TOGA Central

Response to Submission

TOGA

November 2022

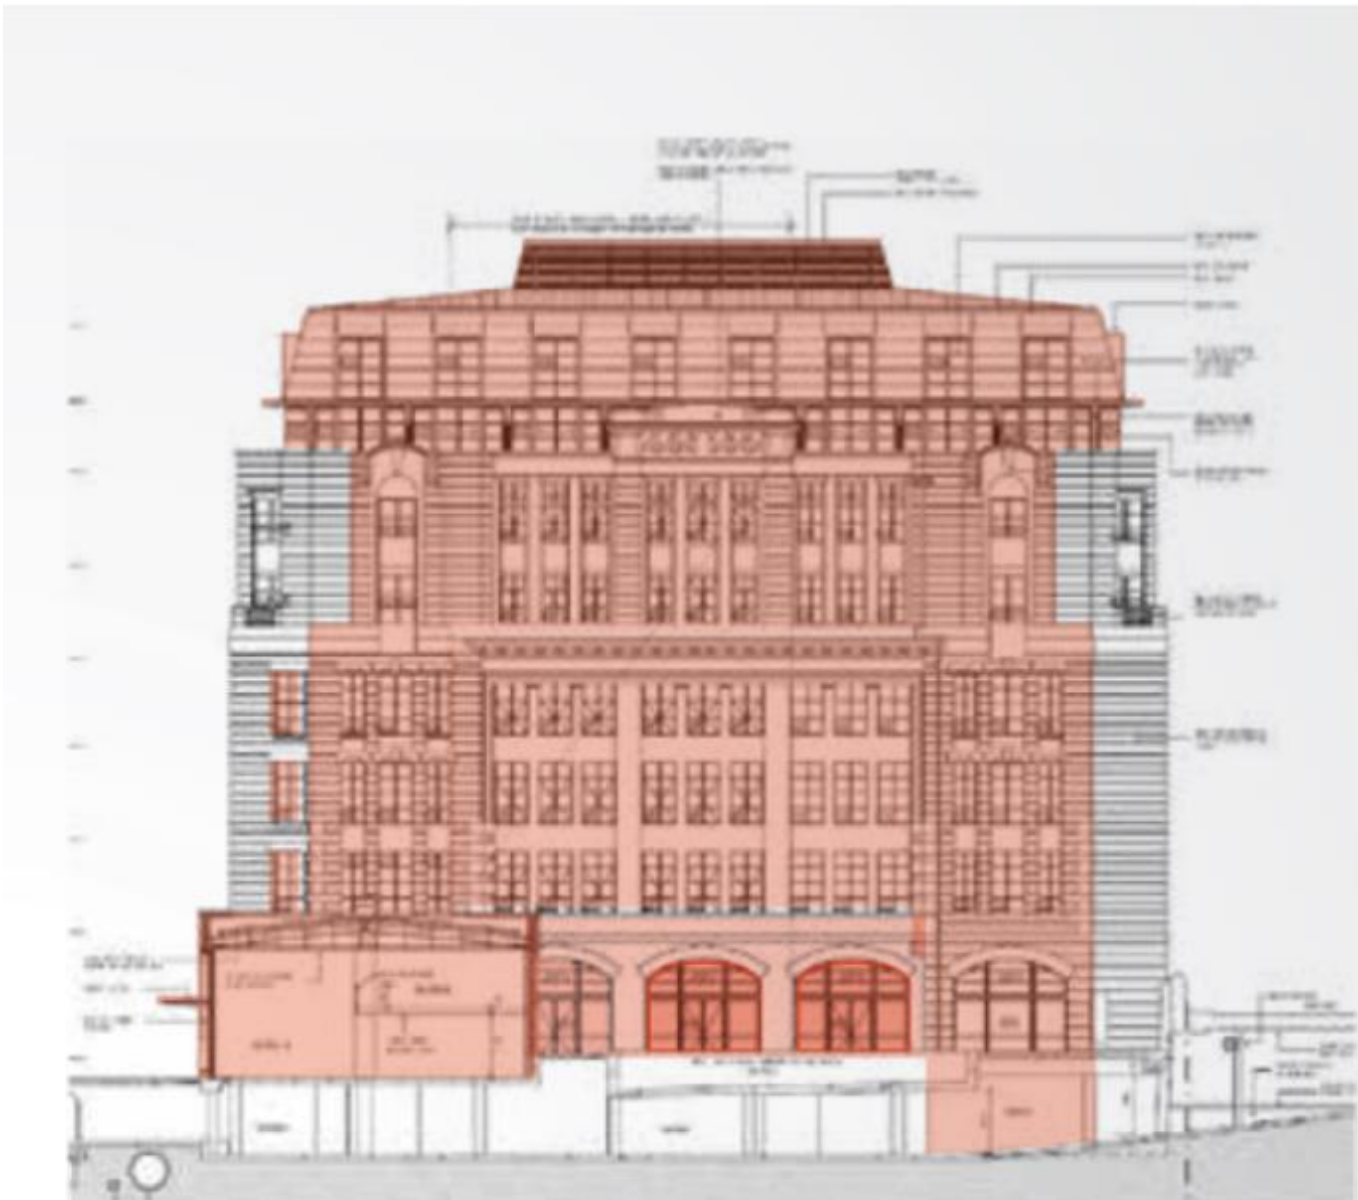
The Department notes Council’s concern about the heritage impact of the demolition of the south-east corner of the fPPb. Provide additional information on the option analysis that informed the design of the proposal, including consideration of the amenity, built form and setback and visual implications of an option to retain the south-east corner of the fPPb.

Also CoS item 3.1
Demolition of external facades

Response
The building is organised around the understanding of little heritage value of the east facade. Adjacent diagram describes the alterations subsequent to initial construction in orange.

As a consequence, the main building core of the tower is located as far east as possible to minimise impact to the authentic parts of the heritage building.

fPPb - Typical upper floor - revised design

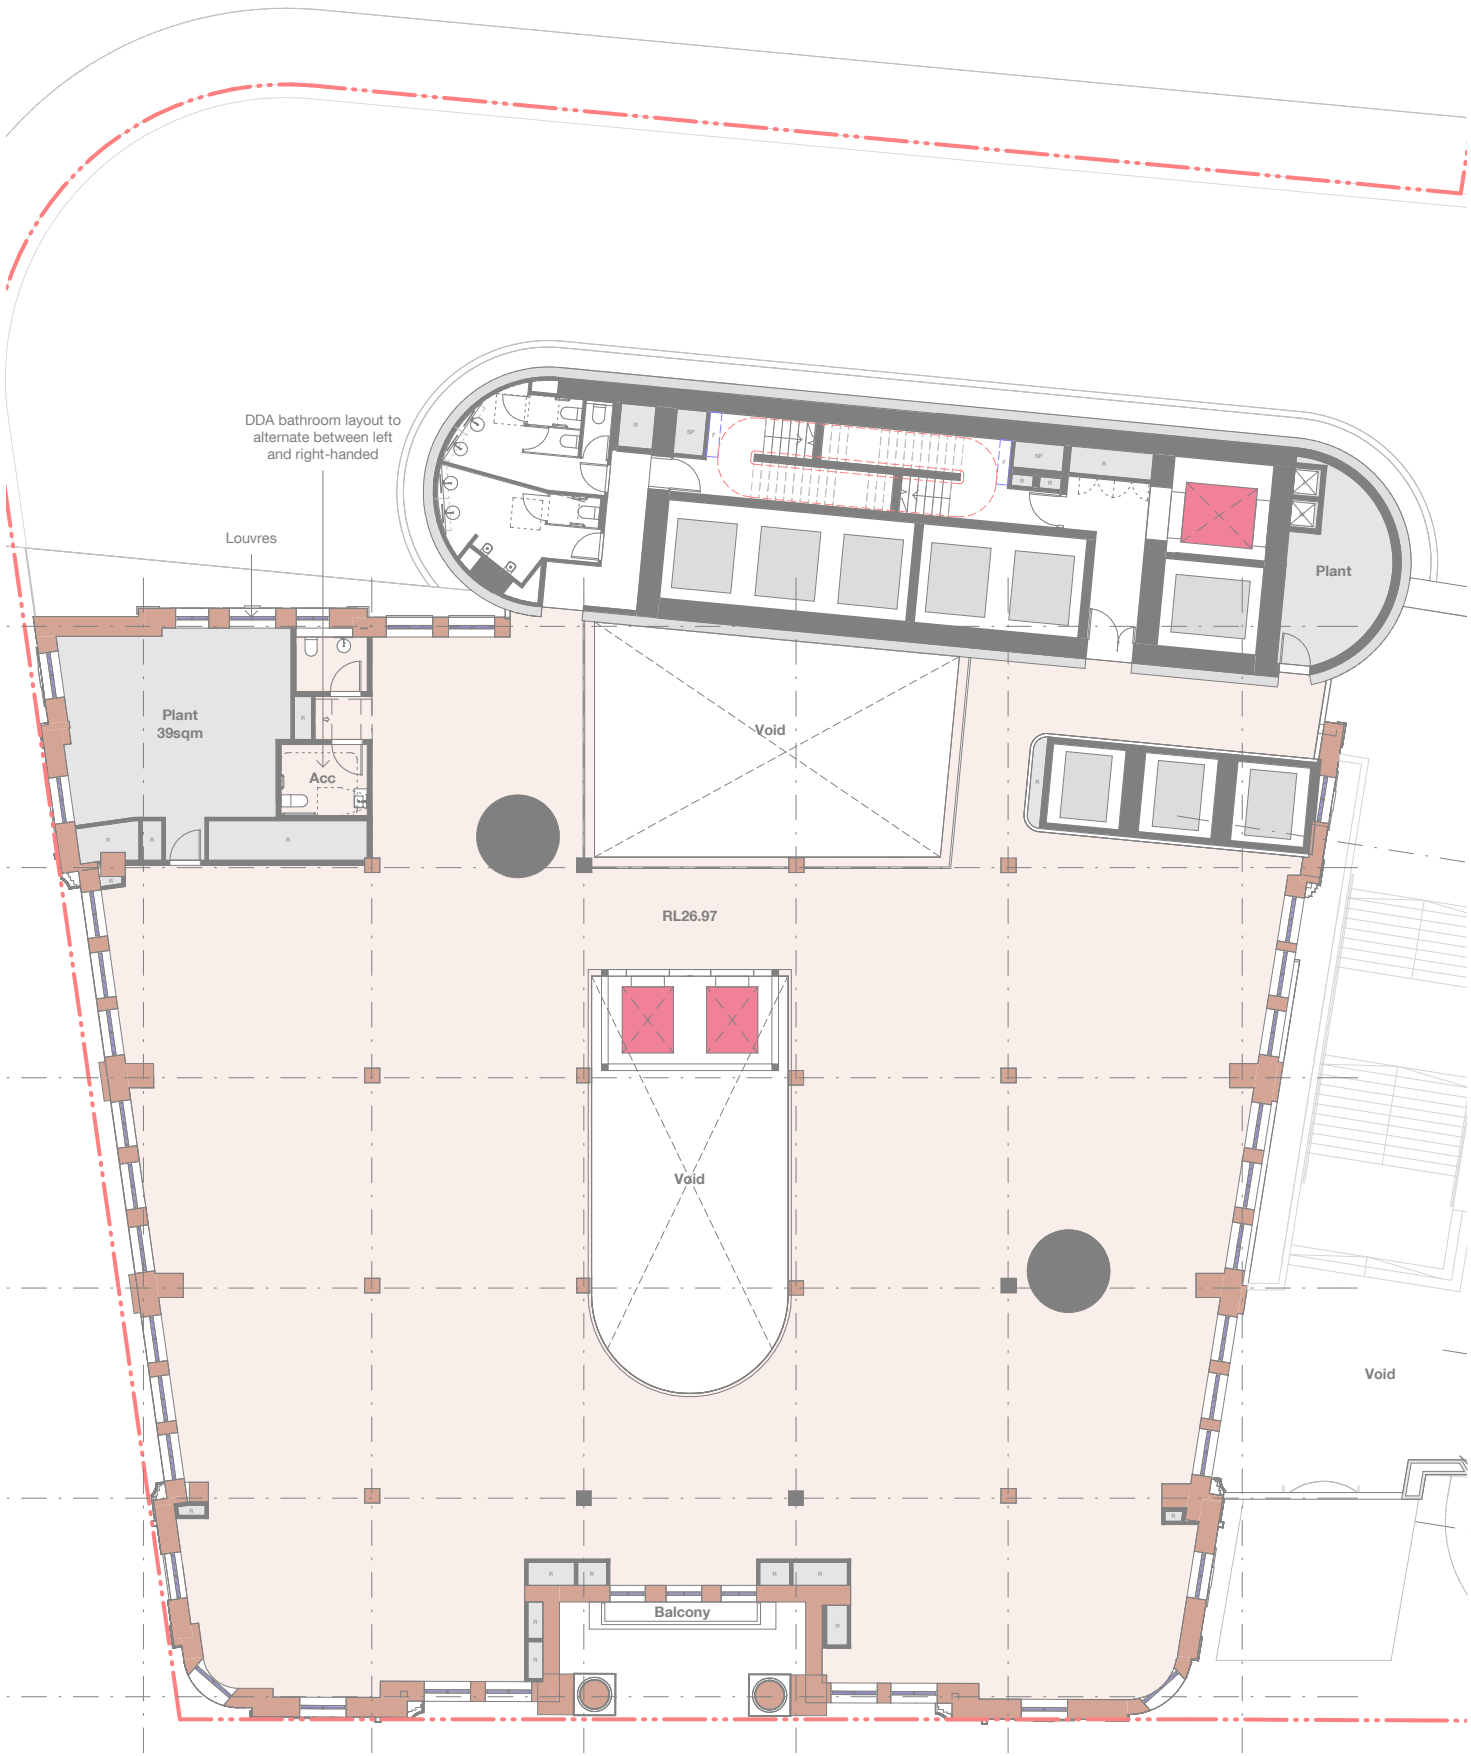
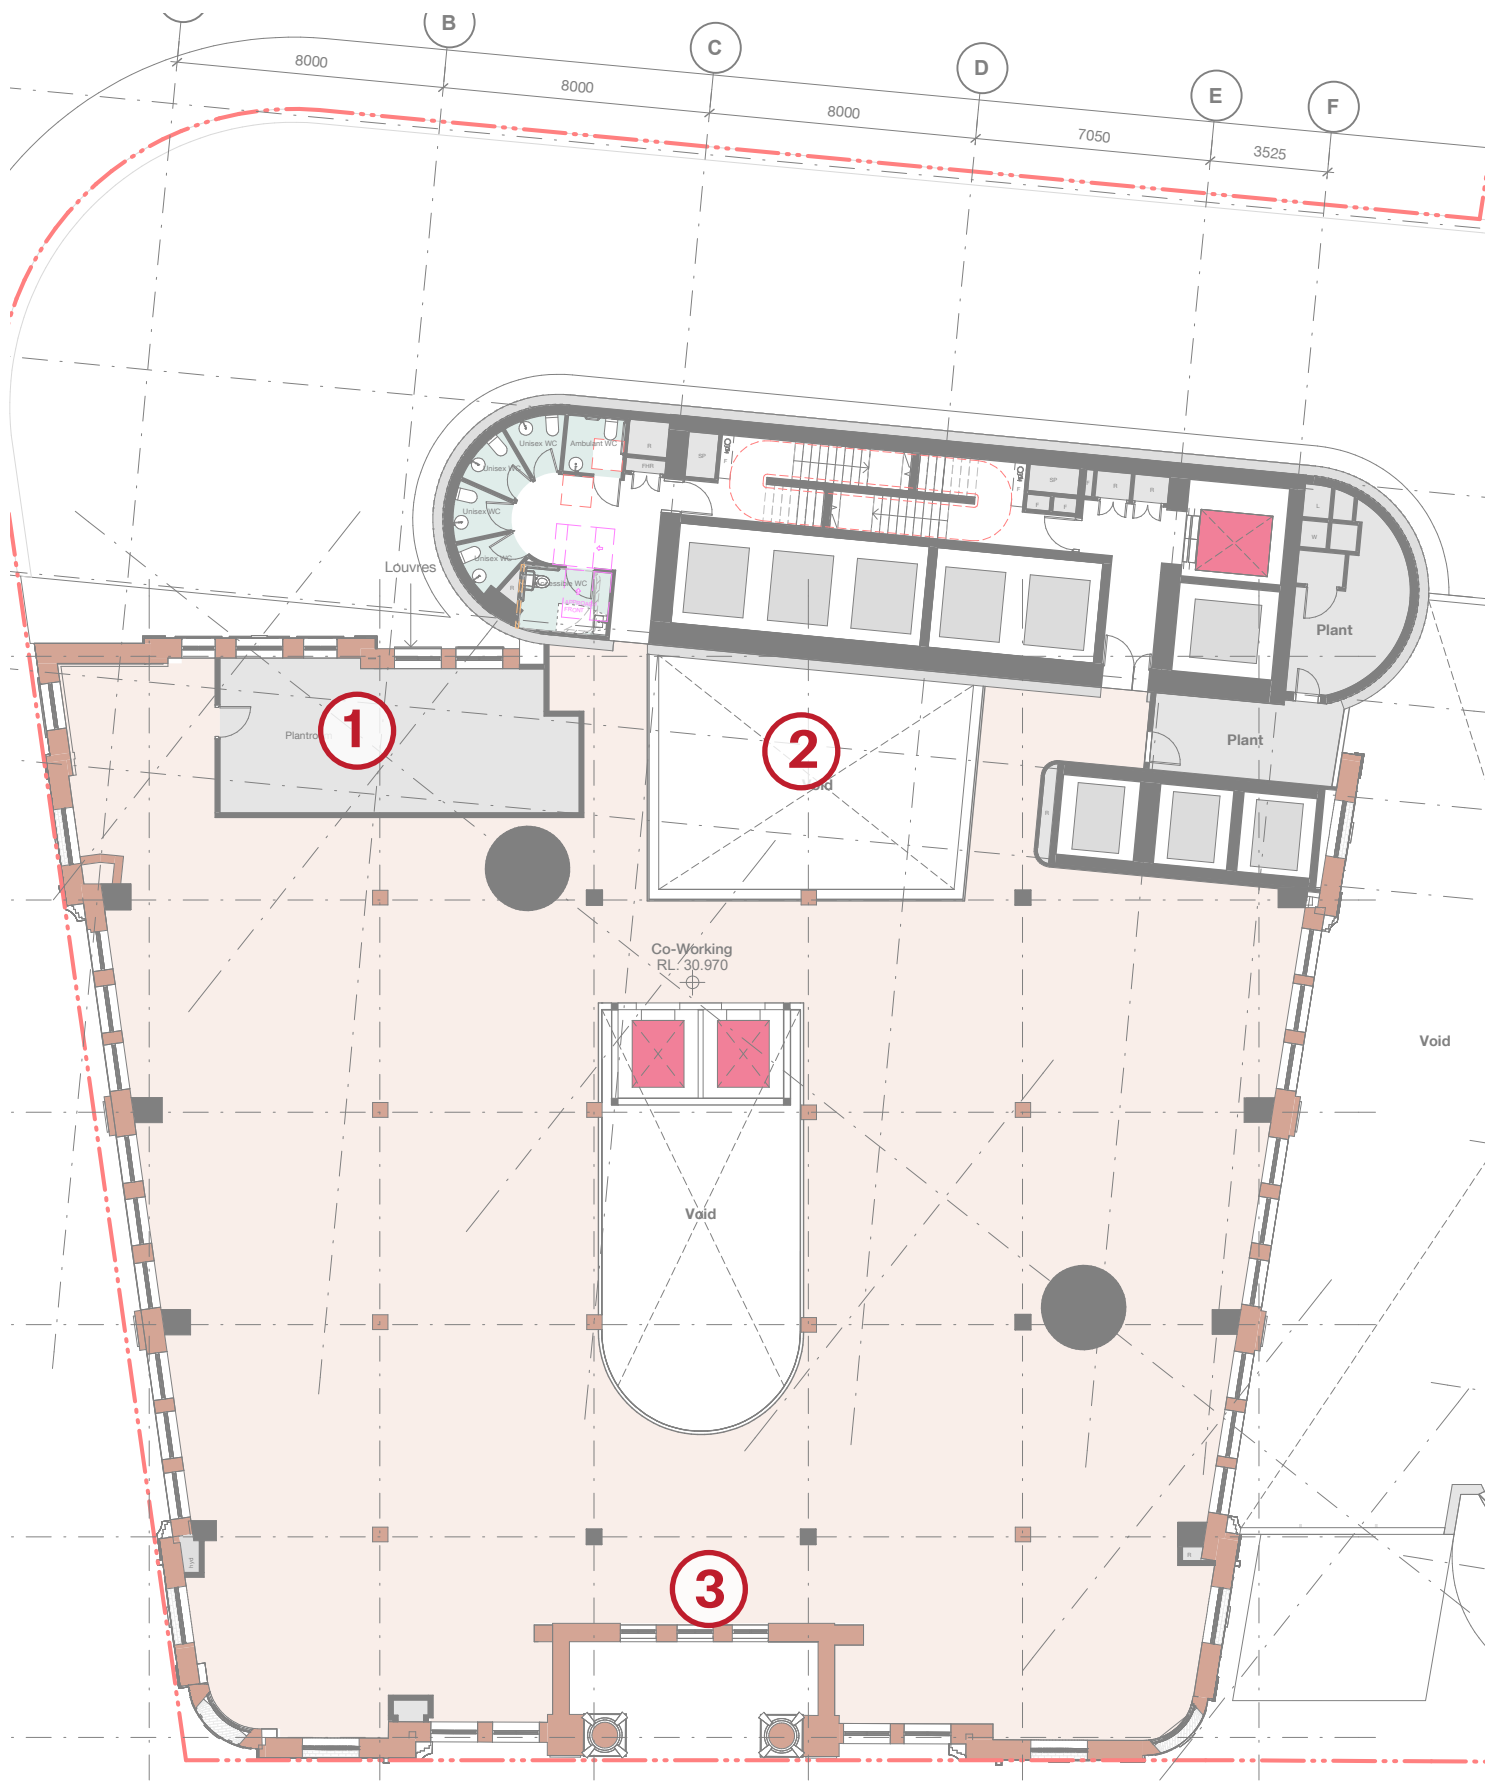
The Department notes the concerns raised by Council about the extent of proposed internal demolition and reconfiguration and the number, size and proportion of new openings within the rear yard retaining wall. In addition, the Heritage Council has stated the internal spatial layout and configuration of the fPPb has heritage significance and should be reinstated where possible. The Department recommends the proposal is further refined/ amended to address the above key comments raised by Council and the Heritage Council to ensure heritage impacts are minimised.

Of particular concern is the quantum of insertions proposed within the building between Grids A and B (see Figure 2 below), which reduces the floor plates to a fragmented series of passageways. The plant room, column, void and lift core result in almost total demolition of the floor plates in this area

The Design has been further developed in response to these concerns as follows:

- 1** - on floor plant rationalised, improving internal floorplate and extending floor to north east corner
- 2** - void reduced in size, allowing direct access into core
- 3** - Risers relocated - improving Western internal facade

These adjustemts improve the quality of the floorplate for a more contiguous space and omit unnecessary dead areas.
